Evoenergy 2024 to 2029 Regulatory Proposal

REVIEW OF PROPOSED EXPENDITURE ON DER AND AUGEX

Report prepared for:
**AUSTRALIAN ENERGY
REGULATOR**
August 2023

Figure 3.4: Volume weighted average CECV

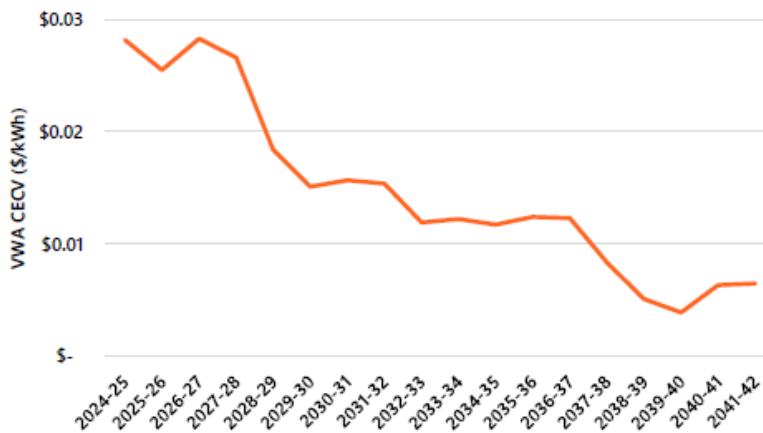
64. Evoenergy has calculated future curtailments based both on inverter tripping (due to overvoltage) and on an assumed reduction in static export limits.
65. Evoenergy has assumed a reduction in static export limits for new customers of 0.1kW per year, starting from the current level of 5.0kW in 2024-25. Therefore, for example, Evoenergy has assumed static export limits of 4.3kW would apply to new PV customers connecting in 2029-30 and 2.9kW for new PV customer connecting in 2039-40.
66. Evoenergy has not explained the rationale for its assumed 0.1kW per year reduction in new PV static export limits. However, from inspection of its modelling of CECV, we observe that its assumed curtailments from this source are much less than assumed inverter-related curtailments, as is shown in Figure 3.5.
67. Evoenergy has applied the AER’s CECV, which has a declining trend, as shown in Figure 3.4.

Figure 3.5: Forecast cost of curtailment \$m, real FY24

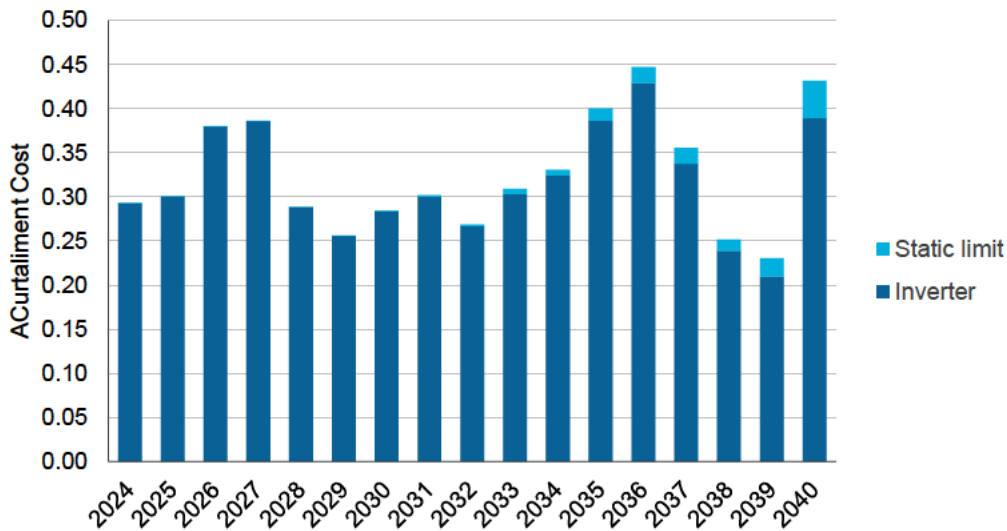
68. The product of Evoenergy’s forecast of curtailment volumes and the CECV is shown in Figure 3.5. While there is annual variability, the overall trend for this cost is relatively flat. To the extent that Evoenergy’s need relies on its assessment of future curtailment costs, this indicates that its analysis is largely driven by current and near-term forecasts and not by speculative assumptions regarding circumstances in the distant future.

Figure 4.3: Evoenergy and alternative non-coincident sum of ZS peak demand forecasts (Winter 50% PoE)

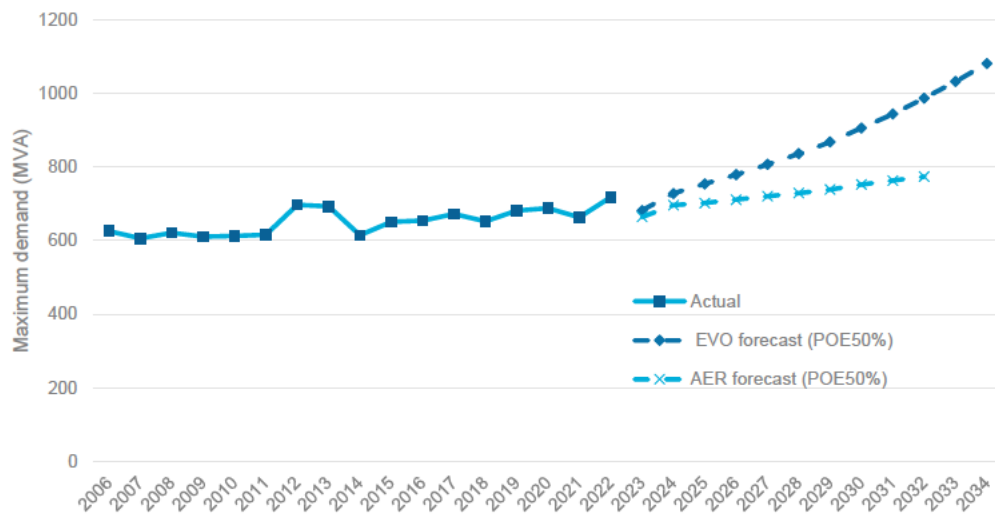
123. Accordingly, we have considered the AER alternative peak demand zone substation forecasts in assessing the justification for Evoenergy’s proposed augex. In Figure 4.3 we show Evoenergy’s historical peak demand, together with the peak demand forecast that it has used as the basis for its demand-driven augex proposal, and AER’s alternative forecast.²⁵ In the historical graphs and tables that follow, the Evoenergy demand forecast refers to that provided under IR#07 as above, and the AER ALT forecasts are the alternative forecasts provided to us by AER as defined above.

132. Consideration of the EV load forecast information above in conjunction with the alternative demand forecast presented in Figure 4.3 also raises doubt over Evoenergy’s assertions that its proposed significant increase in augex in the next regulatory period is in response to ACT government’s Net Zero policy. As can be seen in comparing the scale of Figure 4.3 with that shown in Figure 4.6 above, the impact of the 54% (by 2030) lower revised EV-driven

Figure 4.4: Daily EV charging profile (assumed for 'realistic electrification' scenario)

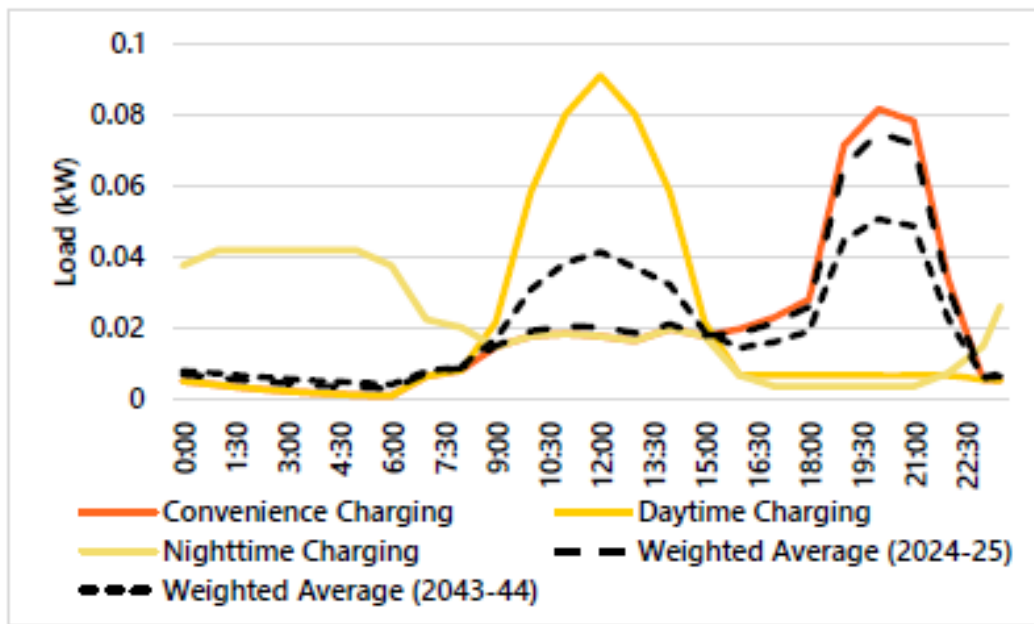
125. From Evoenergy’s description of the basis that it has adopted in forecasting the peak demand impact of EVs, it appears that it is based on an EV charging profile as shown below. As stated in Evoenergy’s Attachment 1.4, the assumption is that ‘...BEV charging will gradually move from convenience charging (charging in the evening peak) in the early years of the study period to increased daytime charging...’

- 126. Evoenergy’s assumed charging profile reflects a considerably slower moderation of EV charging profiles than is evident, for example, in ACIL Allen and GHD’s advice to the ACT government, and which is reproduced in Figure 4.5. By a similar end-point (i.e. 2045 versus 2043-44) the ACIL Allen and GHD forecast suggests that there will be minimal charging during the convenience evening winter system peak window and considerable use being made of the ability to charge through ‘solar soaking’ during the middle of the day.
- 127. We further observe that moderation of this profile is to a considerable extent linked to Evoenergy’s proposed DER initiatives that we have assessed in section 3.

Figure 4.6: Evoenergy’s original and revised forecasts of EV contribution to peak demand

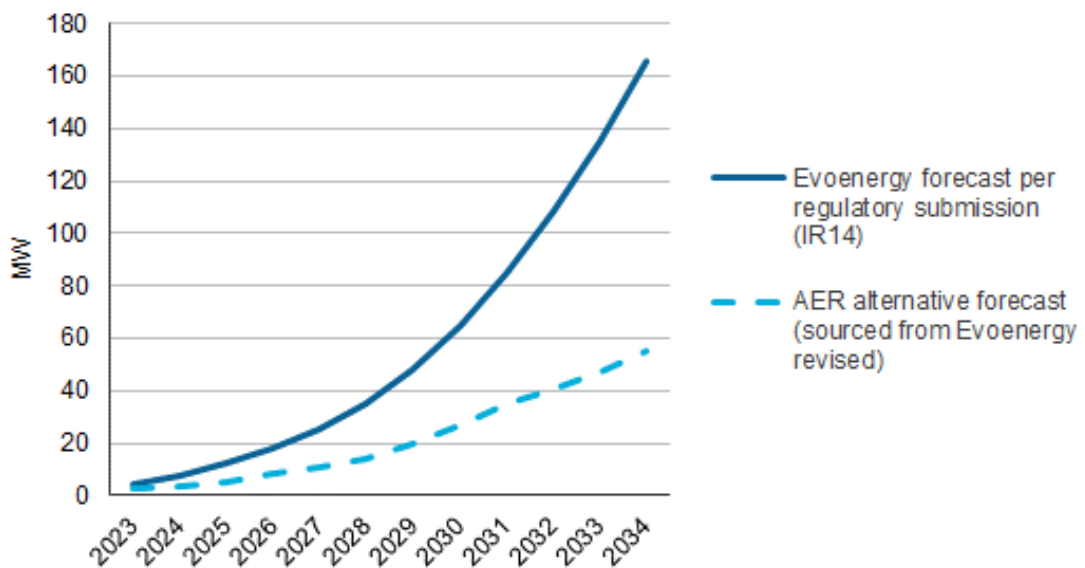
131. In Figure 4.6 we present Evoenergy’s original and revised EV peak demand forecasts. We understand from AER that the ‘AER ALT’ alternative non-coincident aggregate peak demand forecast (as shown in Figure 4.3) incorporates Evoenergy’s revised EV peak demand forecast which is (by 2030) 54% less than the original forecast that it provided.²⁷

Figure 4.7: Woden substation capacity assessment – winter period

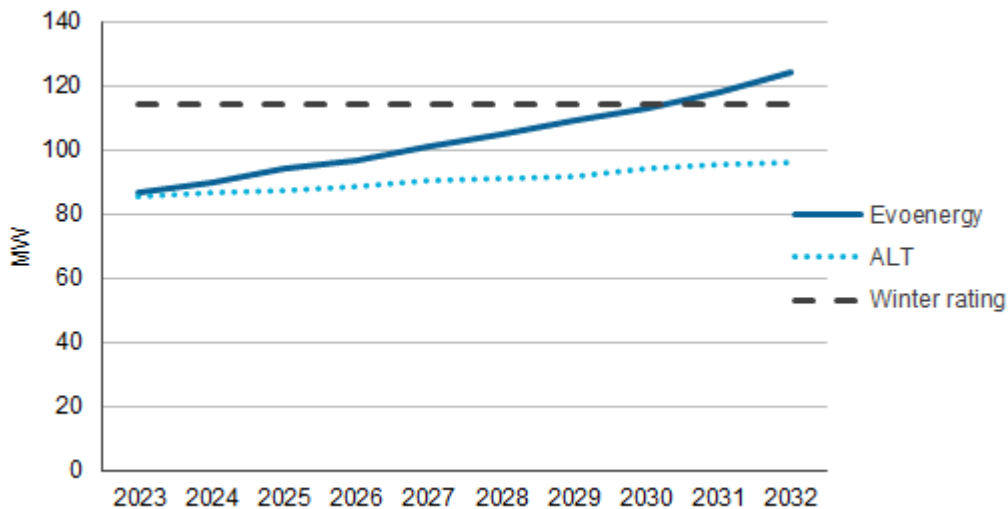
- 154. We consider that Evoenergy has demonstrated that:
 - The modifications to its existing feeder network have enabled it to defer augex during the current RCP;
 - Through a RIT-D process, it has extended the need for completion of Stage 2;
 - It has reasonably identified that a staged transformer option is appropriate to meet future demand growth in the Molonglo Valley.
- 155. However, the timing of the need for the transformer installations is determined by the demand forecast that is applied. When the AER's alternative demand forecasts are applied to the load area (as indicated by the Woden ZS loading) we consider that the need for the installation of the second transformer (stage 3) can be deferred beyond 2030, as is illustrated in Figure 4.7.⁴⁴

- 181. As for our evaluation of the Molonglo ZS, which is also driven by constraints at the Woden ZS, we consider the implications of the AER’s alternative demand forecasts for Woden substation, as shown in Figure 4.7, as these inform our assessment of the required timing for the Curtin ZS development.⁴⁶ Applying the AER’s demand forecasts to the Woden substation reduces constraints at Woden ZS and would therefore defer the timing of the Curtin ZS. Under the AER’s alternative demand forecast, the Woden ZS would not exceed its Emergency 2-hour rating (at 10% POE) before 2032.

Figure 4.10: City East rating assessment – Winter period

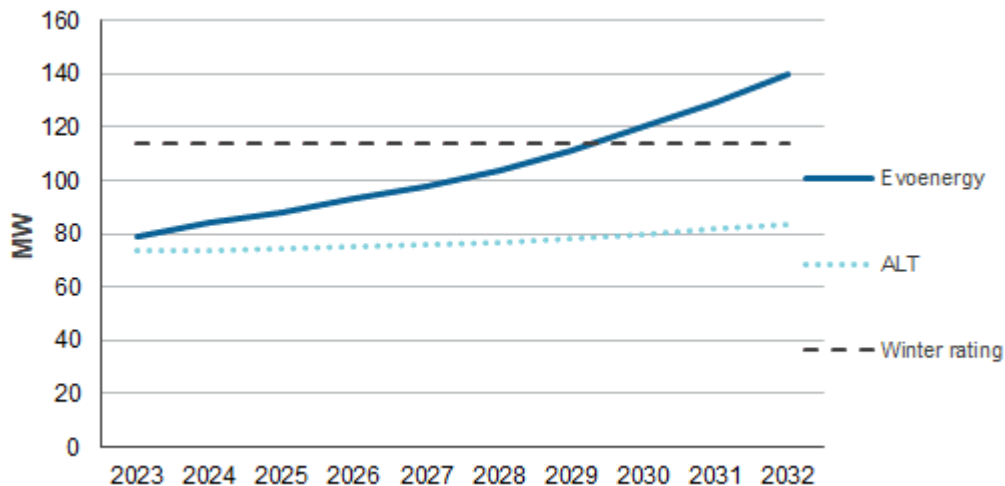
- 188. The need and timing for additional capacity was established by Evoenergy based on its demand forecast. As for other zone substation augex projects we have considered, changes in the demand forecast have the potential to move the timing date for completion of the Mitchell ZS.
- 189. Under Evoenergy’s demand forecast the rating of the City East ZS would be exceeded in 2030. However, when we apply the AER’s alternative demand forecast to the City East ZS, we find that the load would not exceed its Emergency 2-hour rating until sometime beyond 2032 (being the limit of AER’s alternative demand forecast).

- 190. We conclude that adoption of the AERs alternative demand forecast as the basis for determining the commencement date would defer the necessary commencement of this project and associated expenditure beyond the next RCP.
- 191. We note an error in Evoenergy's Options 1 and 2 in the table provided on pages 26 and 27 of Appendix 1.17. A corrected table is provided in Table 4.6, which shows the correct total for Option 1 if the contributing yearly values are correct as \$1.77 million, and not \$2.20 million.

Figure 4.11: Gold Creek loading assessment – Summer peak demand

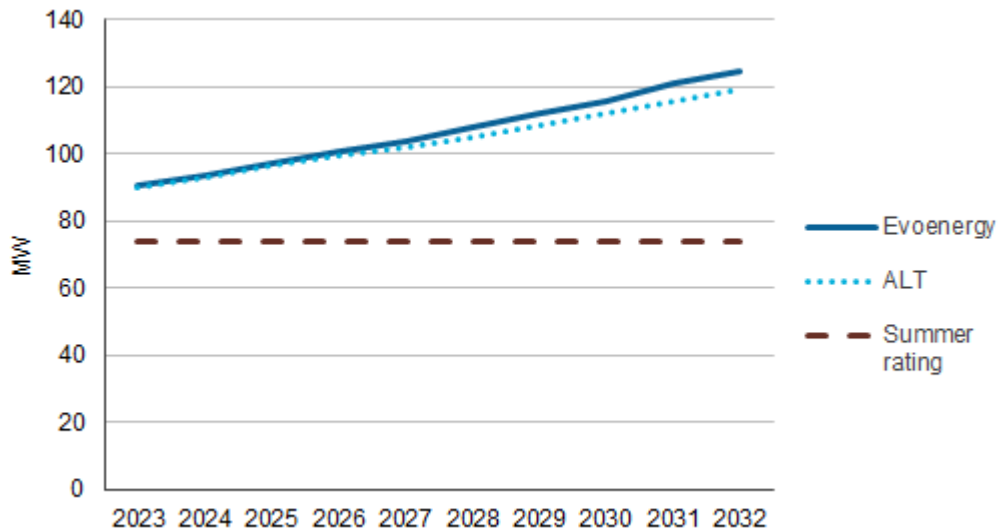
199. The information provided by Evoenergy indicates that the installation of the third Gold Creek ZS transformer has rolled over from the current RCP.
200. The need for and timing of the third transformer installation is driven by the emergence of constraints against the zone substation emergency 2-hour ratings. In Figure 4.11, we show that the emergency 2-hour rating for Gold Creek ZS was already exceeded in 2023. Our analysis of the implications of the AERs alternative demand forecasts on the timing of the need for the third transformer can be seen in Figure 4.11 below.

Figure 4.12: Actual and forecast reliability and quality capex (\$m2023/24)

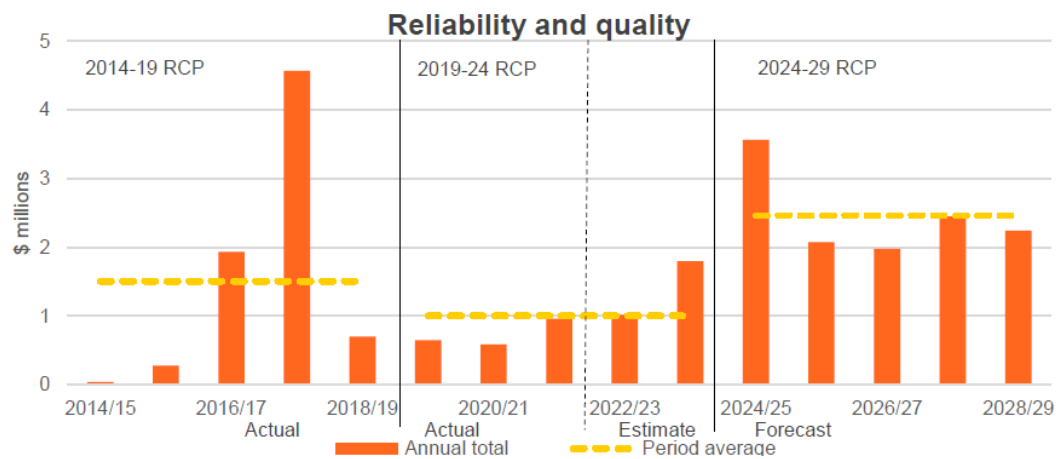
- 233. Evoenergy proposes \$12.31m reliability and quality capex for the 2024 – 29 RCP. This is \$5.31m above the regulatory allowance for the 2019 – 24 RCP, as is shown in Figure 4.12.
